RENOVATIONS / ALTERATIONS
for:
PARAMOUNT 1.5
934 E. McMILLAN ST.
 CINCINNATI, OH 45206
 WALNUT HILLS NEIGHBORHOOD
 NR PROJECT NO. 23-011

ADDENDUM #1 / PERMIT SUBMITTAL	09.22.2023
PRICING ISSUANCE	09.01.2023
Issuances / Revisions / Submissions	Date

Drawing Title
FLOOR & REFLECTED CEILING PLANS

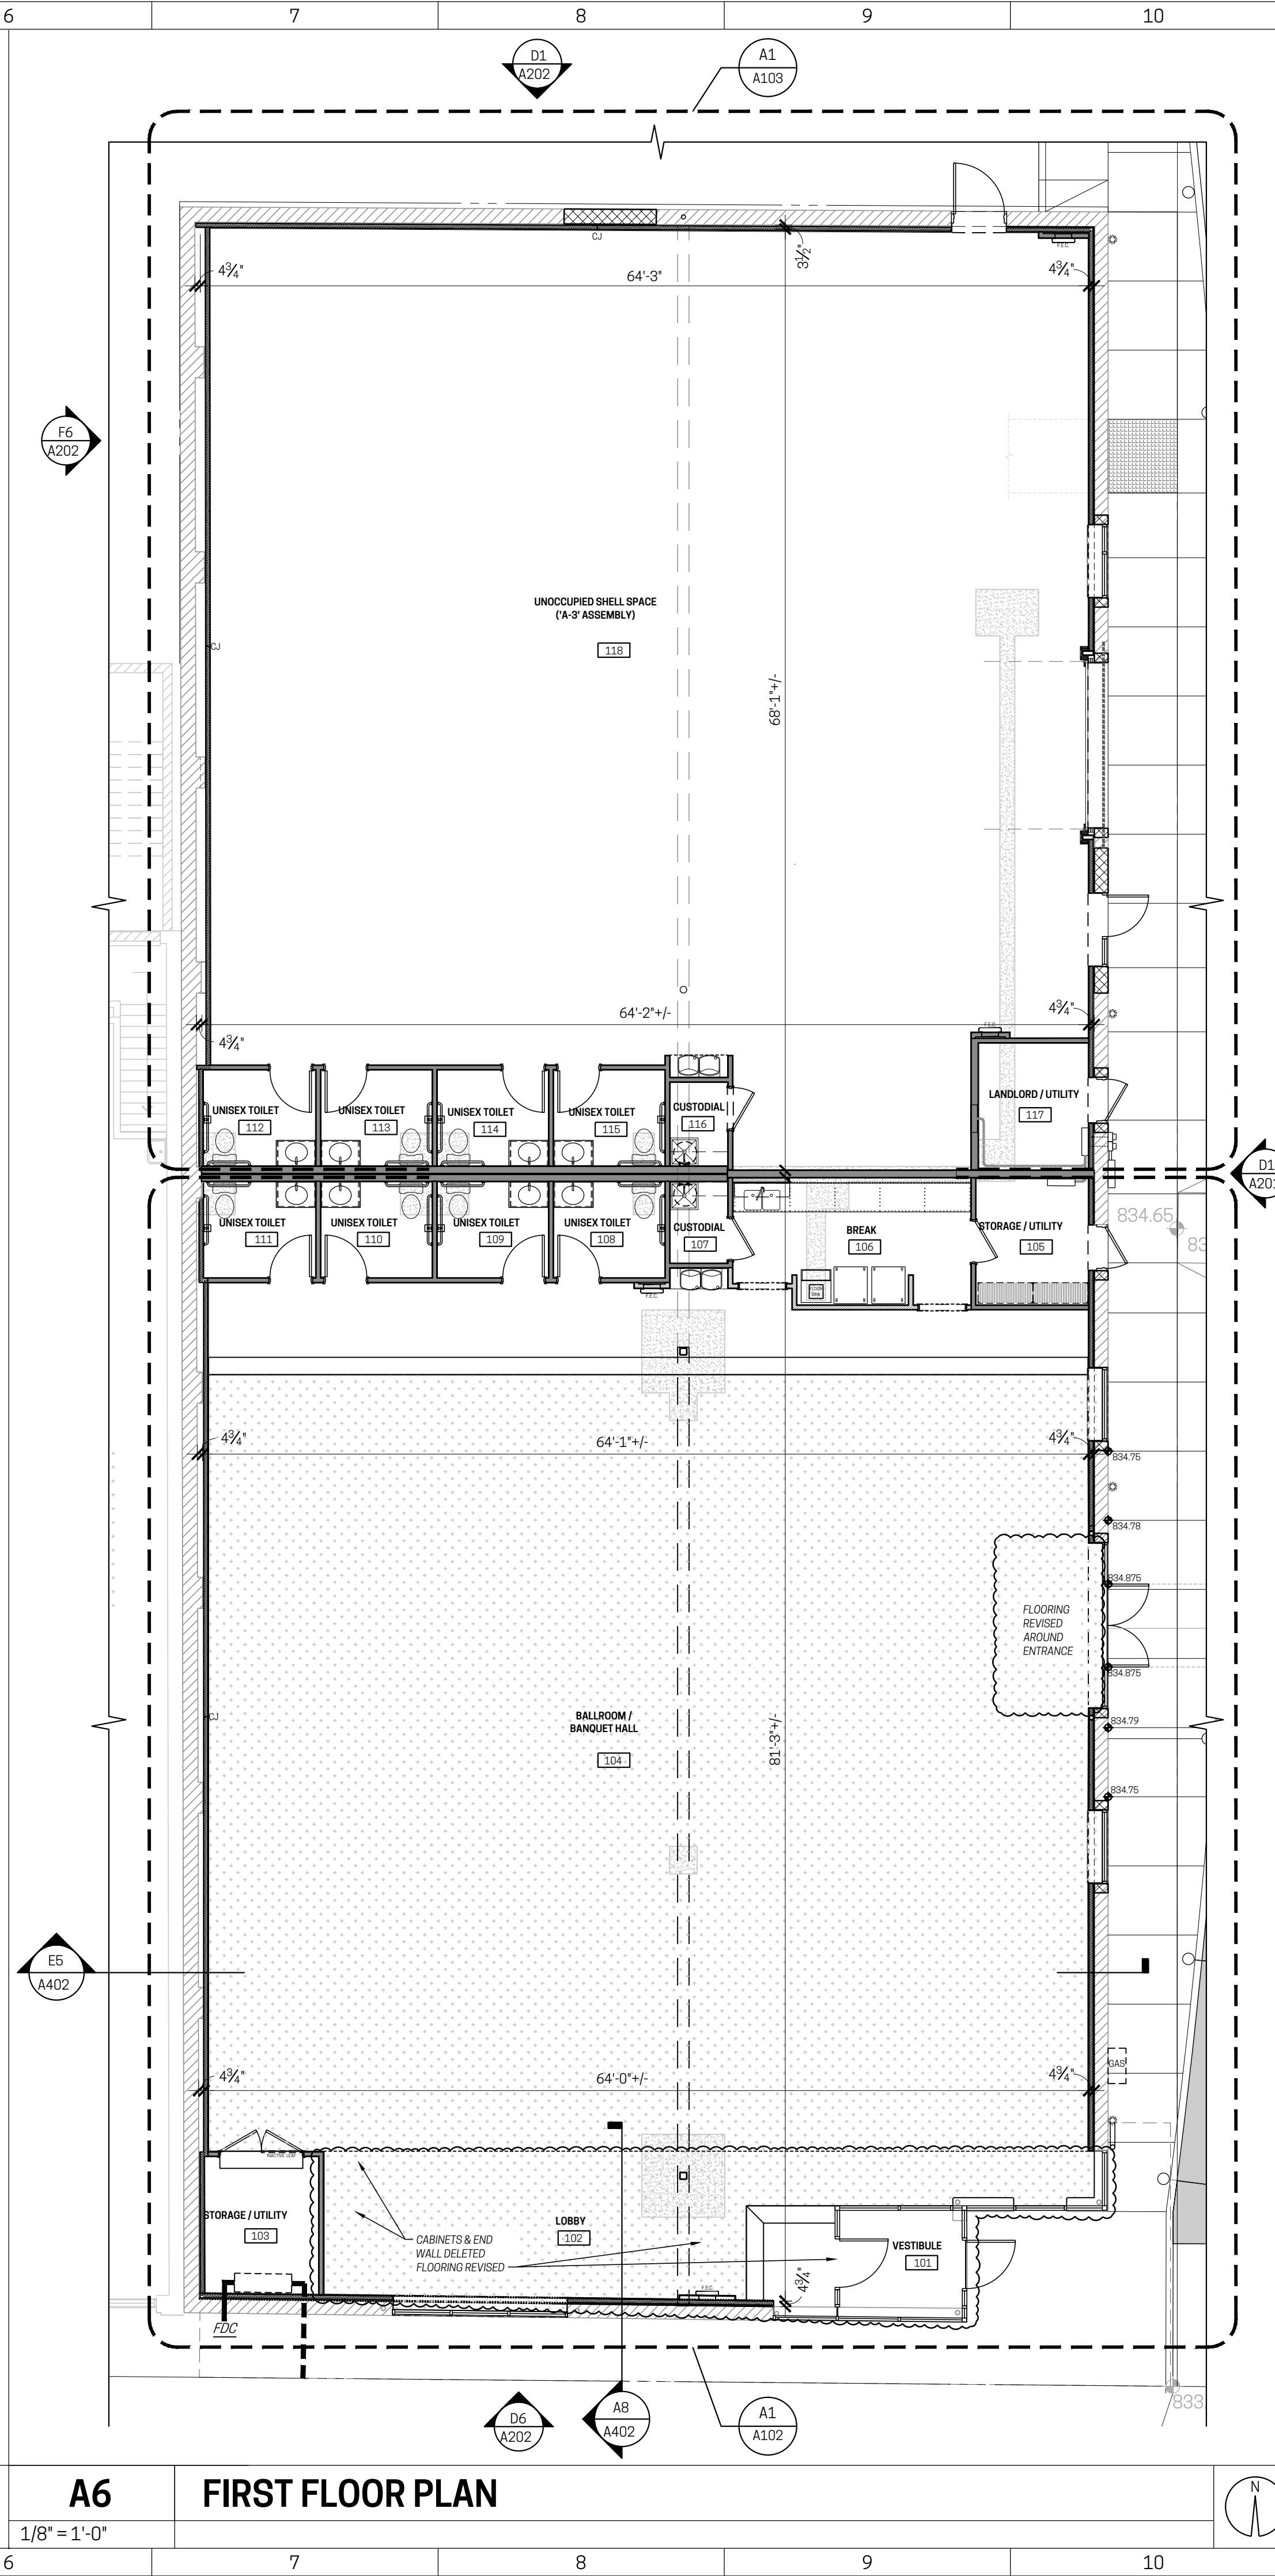
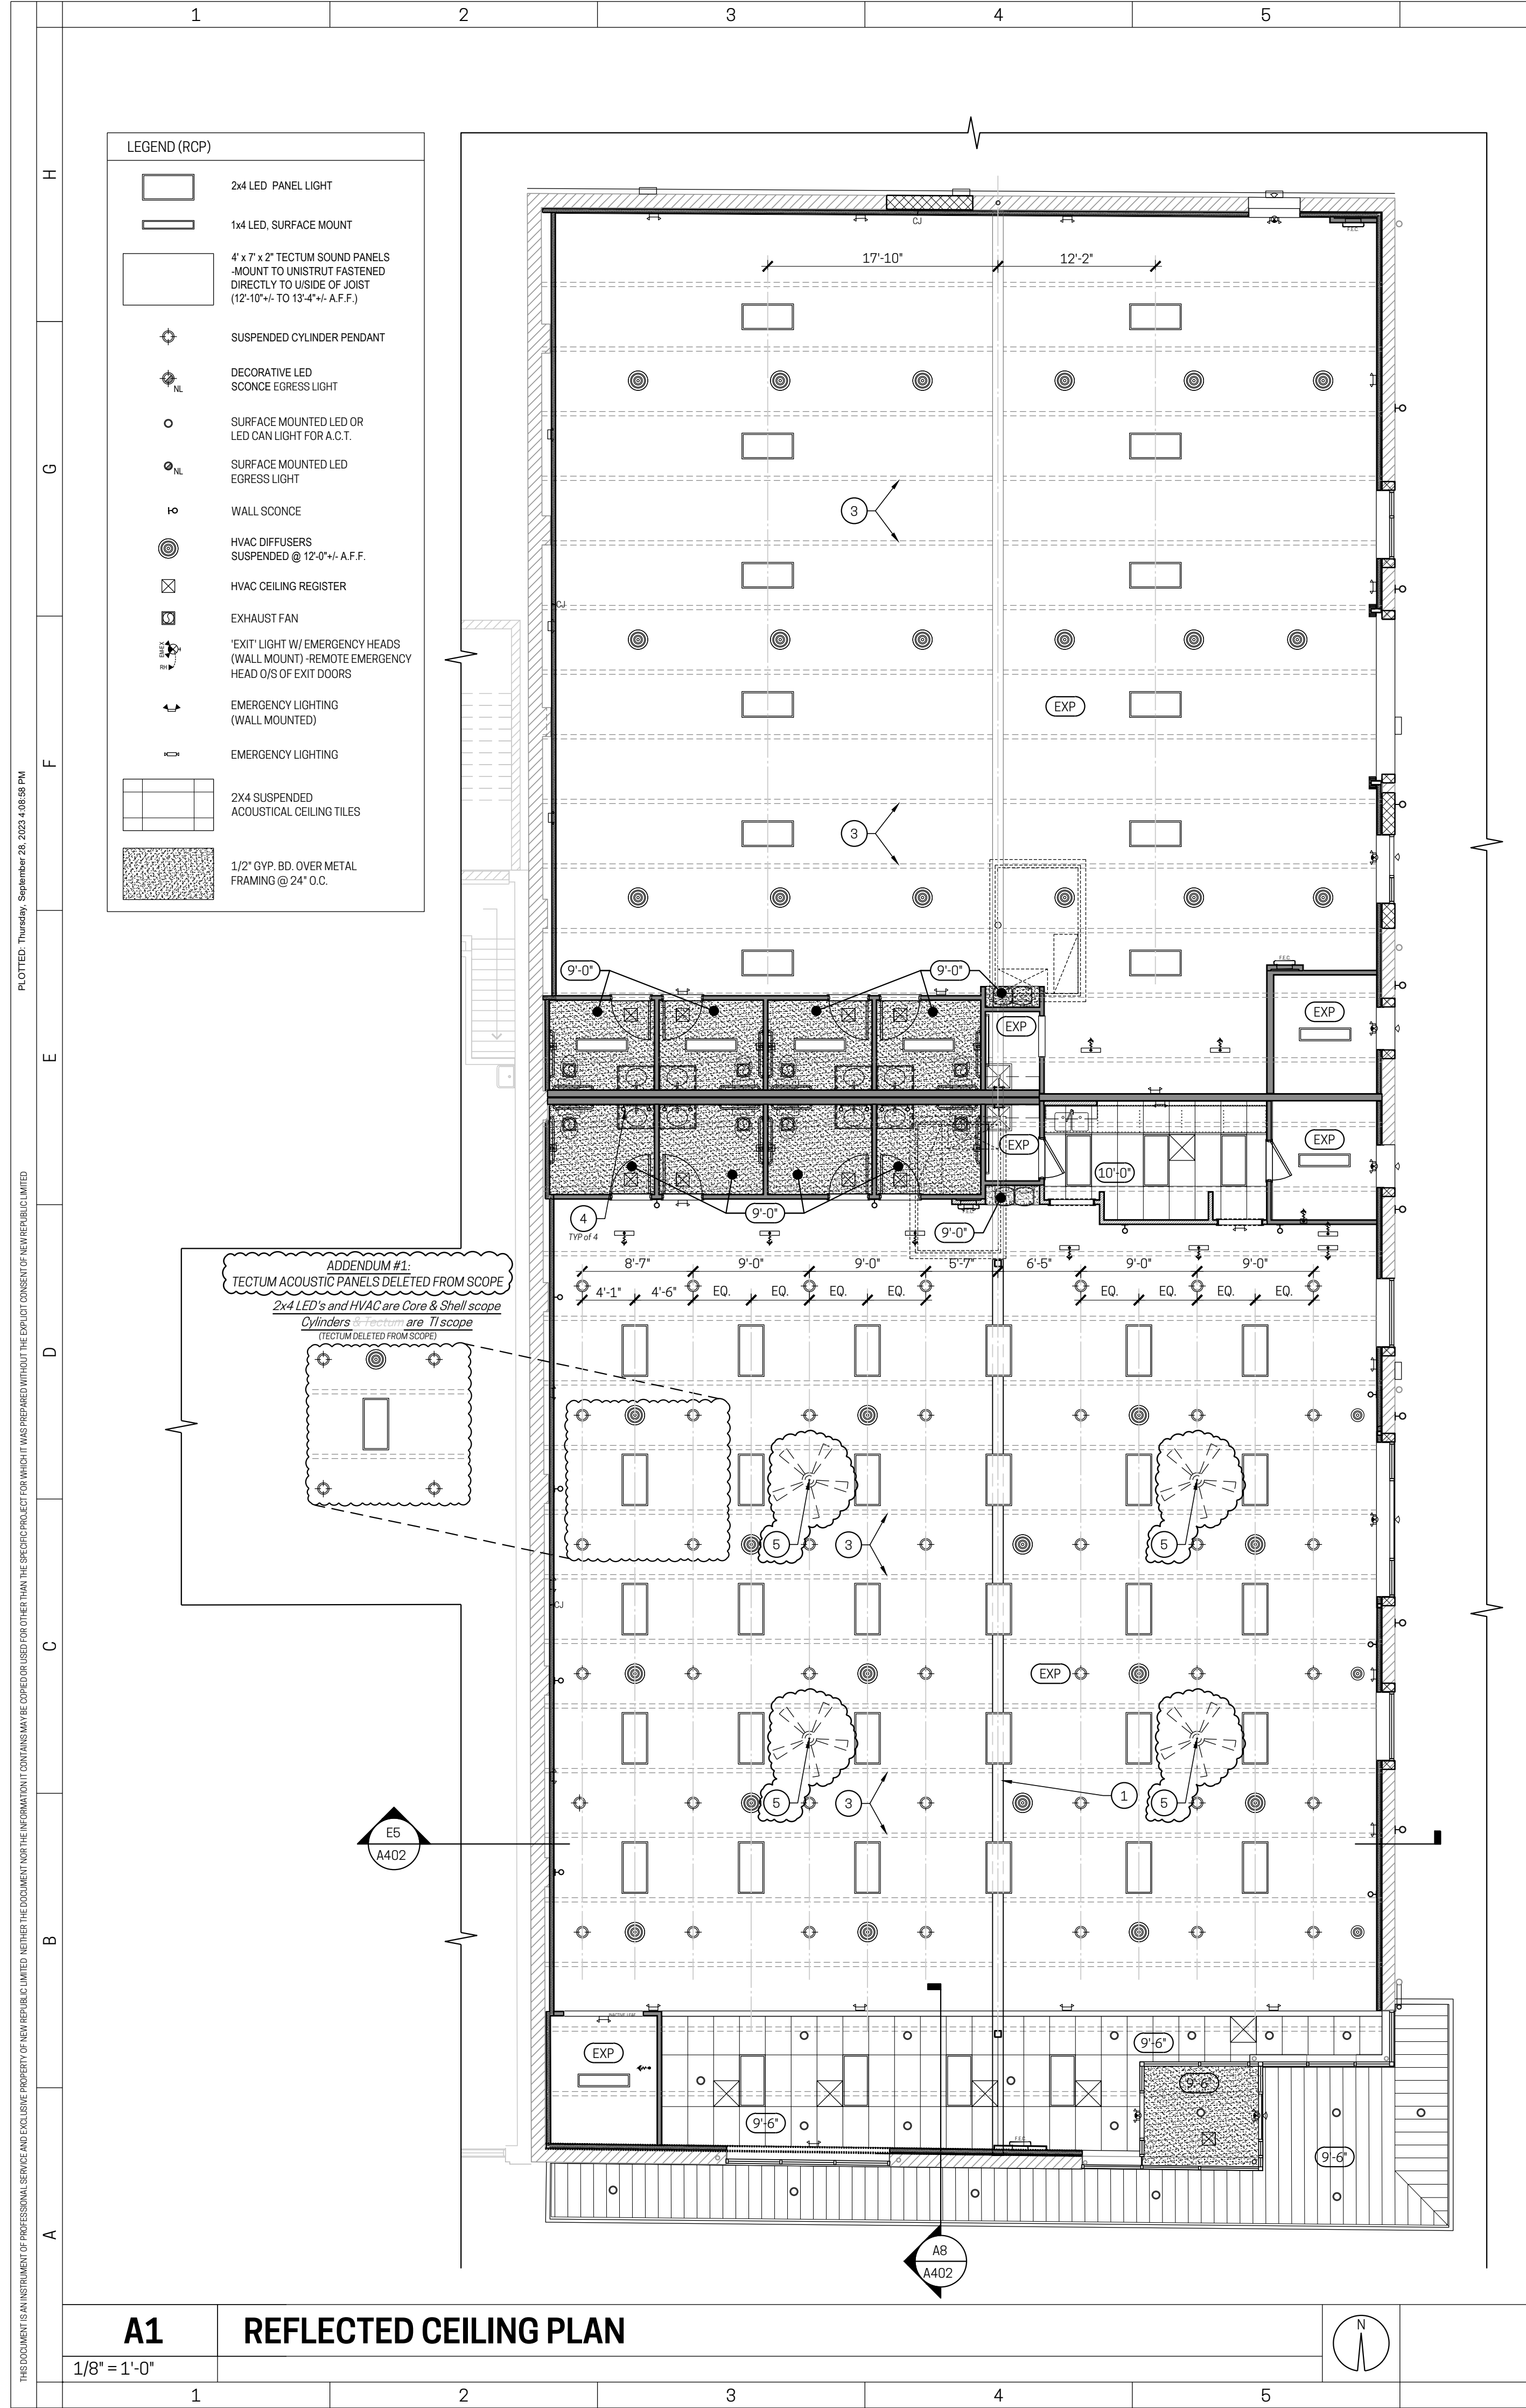
- MODIFIED GIRDER BEAM - SEE STRUCTURAL DRAWINGS FOR ADDITIONAL INFORMATION
- FASTEN TECTUM AND 2'x4' LED PANEL LIGHTS TO UNISTRUT - FASTEN UNISTRUT DIRECTLY TO THE UNDERSIDE OF BAR JOIST (DELETED FROM SCOPE)
- EXISTING BAR JOISTS - TYP.
- PROVIDE LIGHTED MIRRORS IN PLACE OF CEILING LIGHTS IN FRONT TENANT SPACE TOILET ROOMS (TYP OF 4)
- 72" CEILING FAN - SUPPLIED BY TENANT (ADDENDUM #1 - ADDED TO SCOPE)

Drawing Title
ENLARGED TOILET RM PLANS & DETAILS
Document No.

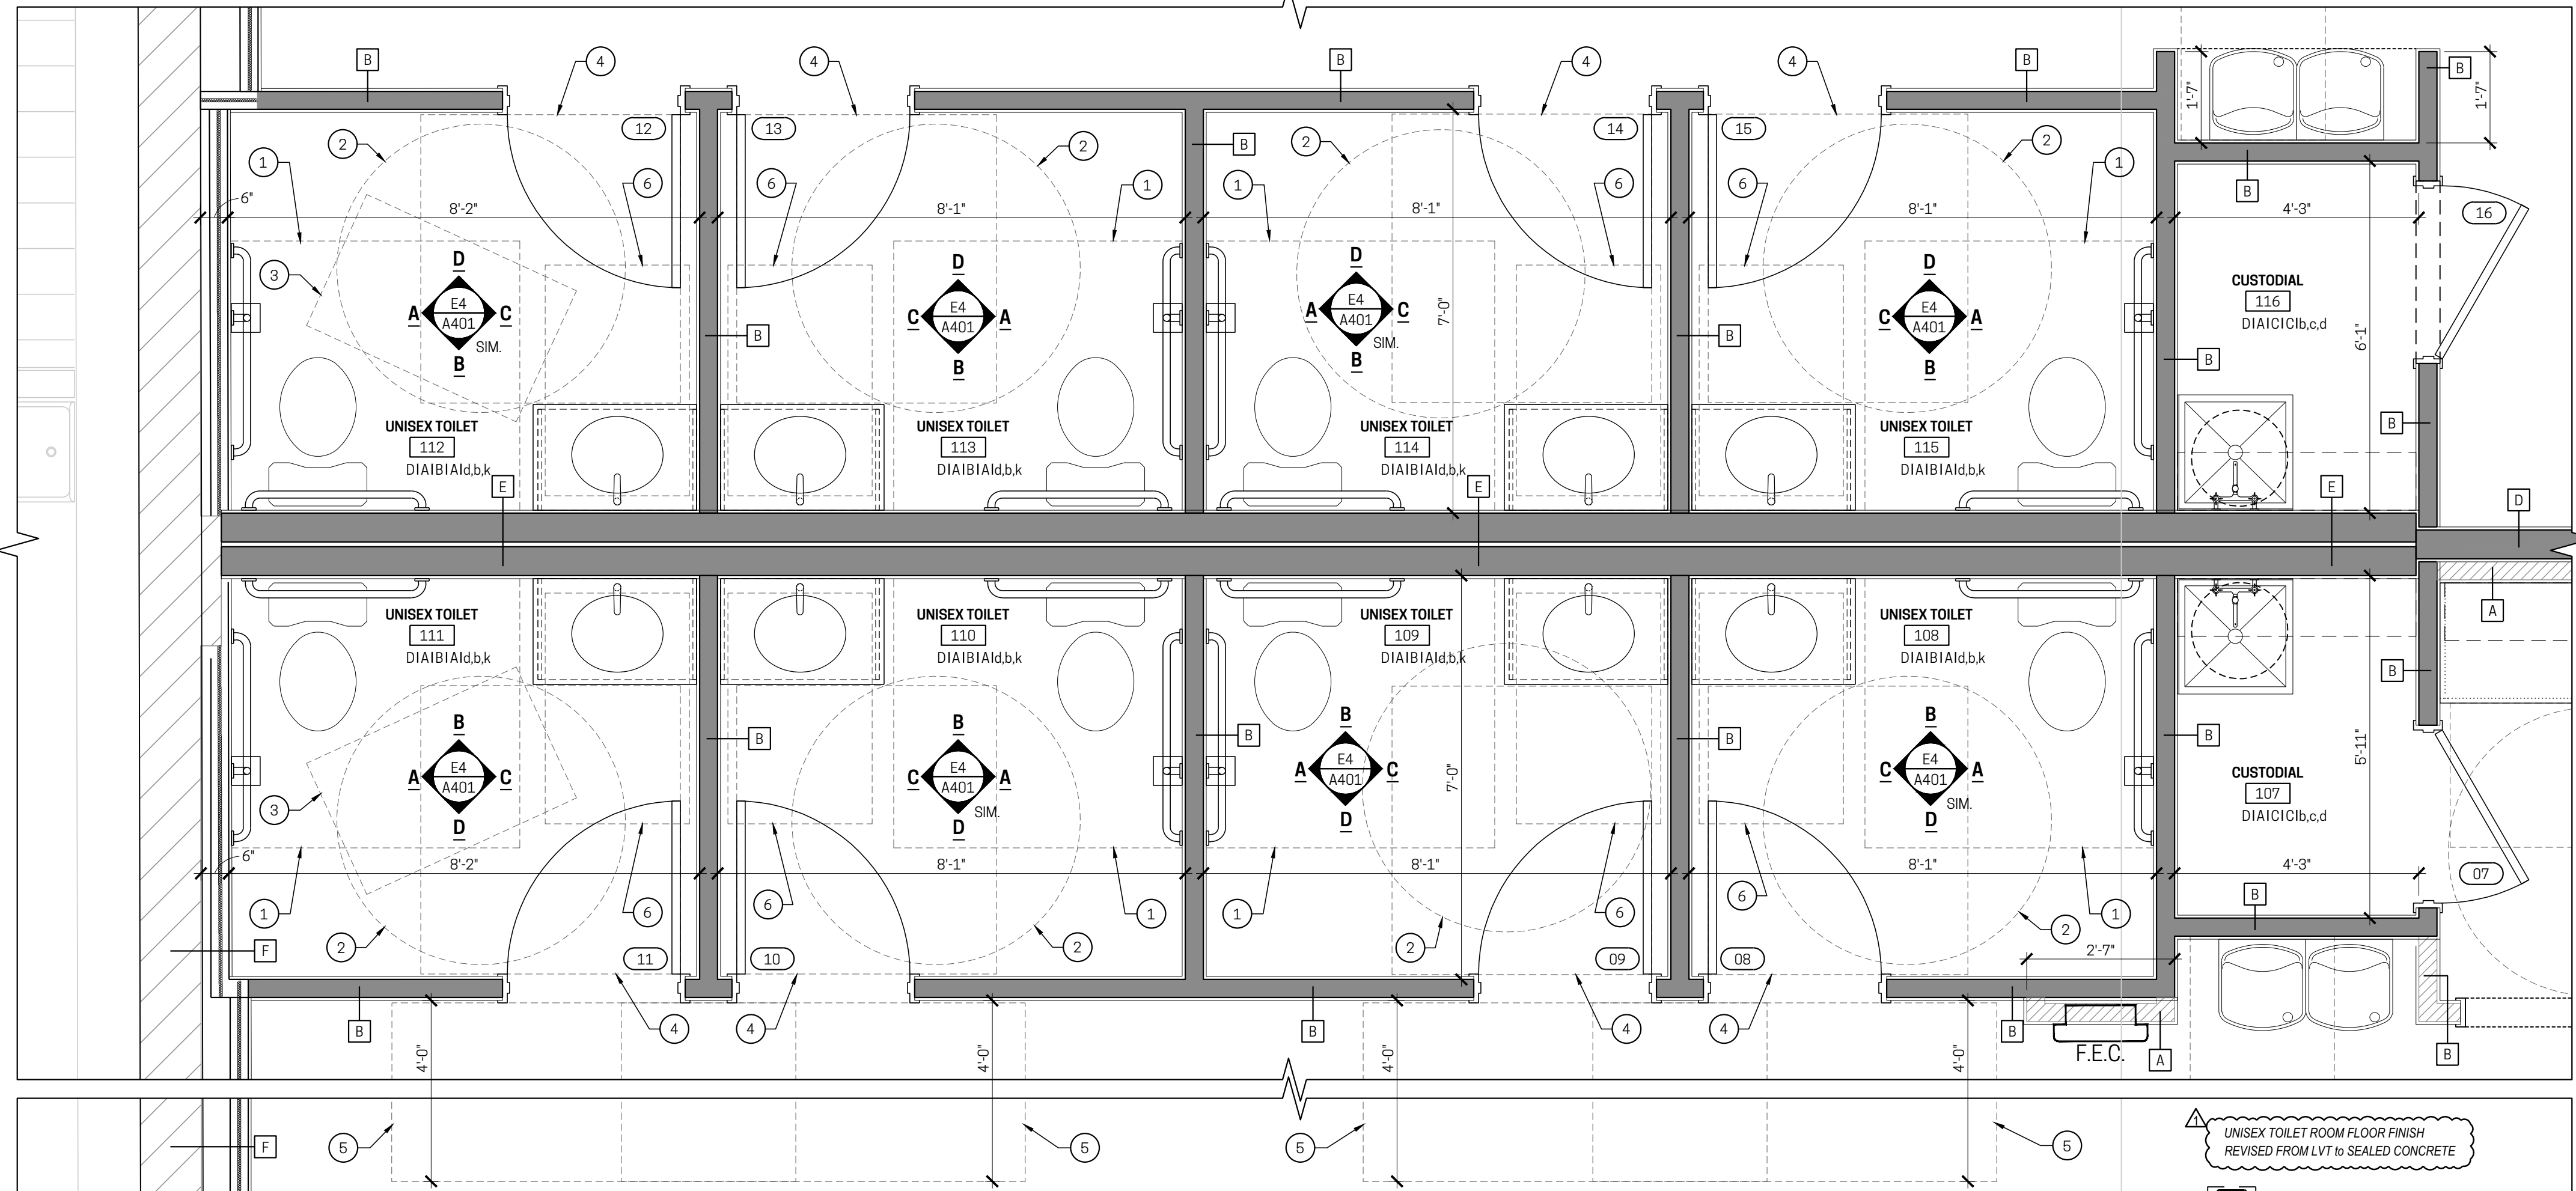
• SPRUNG STYLE DANCE FLOOR FINISH REVISED FROM WOOD to RESILIENT
• RECTAM CEILING PANELS DELETED FROM SCOPE (REVISED to DRY-FALL PAINT ABOVE)
• UNISEX TOILET ROOM FLOOR FINISH REVISED FROM LVT to SEALED CONCRETE
• SEALED CONCRETE FINISH FOOTNOTE IF MODIFIED BY DESCRIPTION OF SEALED CONCRETE FINISH
